SUBJECT: AMENDMENT NO. 197 TO FACILITY OPERATING LICENSE NO. DPR-49
 (TAC NO. M84943)

DUANE ARNOLD ENERGY CENTER

SAFETY EVALUATION BY THE OFFICE OF NUCLEAR REACTOR REGULATION

RELATED TO AMENDMENT NO. 197 TO FACILITY OPERATING LICENSE NO. DPR-49

Duane Arnold Energy Center Iowa Electric Light and Power Company Technical Specifications
DAEC Emergency Service Water Flow Requirement Figure 4.8.E-1

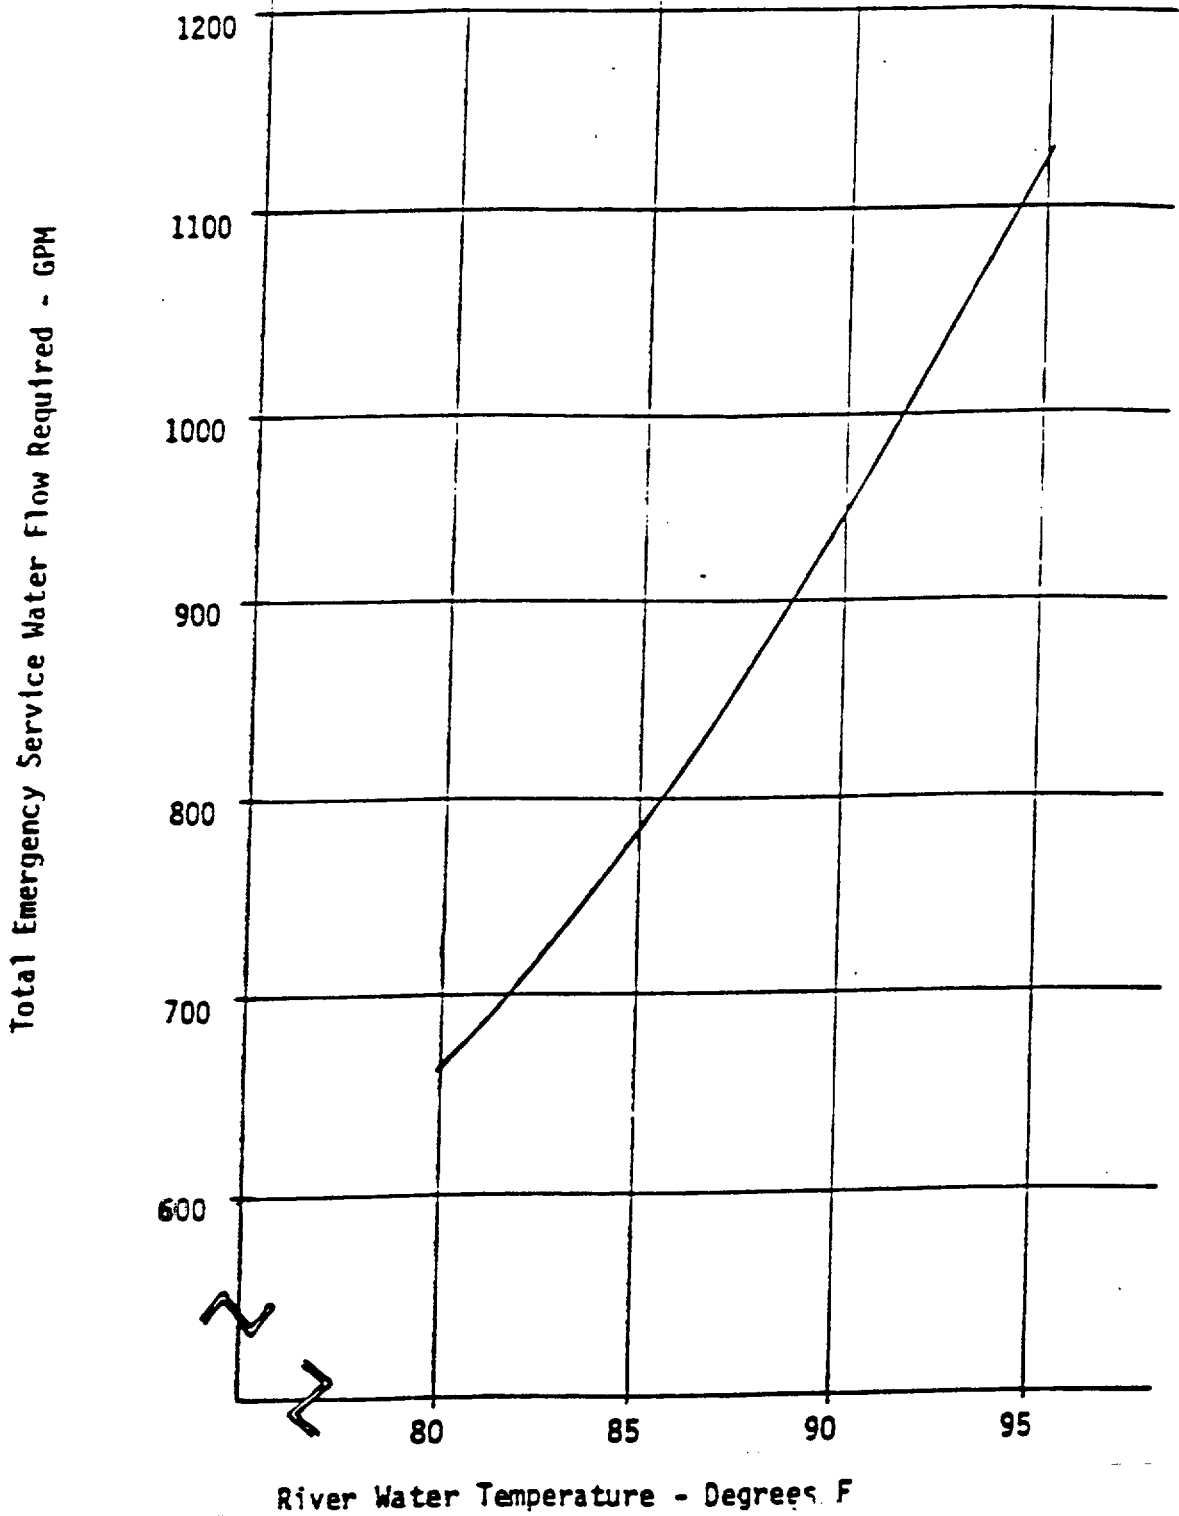
Each Emergency Service Water pump shall deliver at least that flow determined from Figure 4.8.E-1 for the existing river water temperature.	After major pump maintenance and once per 3 months, except weekly during periods of time the river water temperature exceeds 80°F.
---	--
 2. With one Emergency Service Water System pump or loop inoperable, the OPERABLE pump and loop shall be verified to be OPERABLE. In addition, the requirements of Specification 4.5.G.1 shall be met.
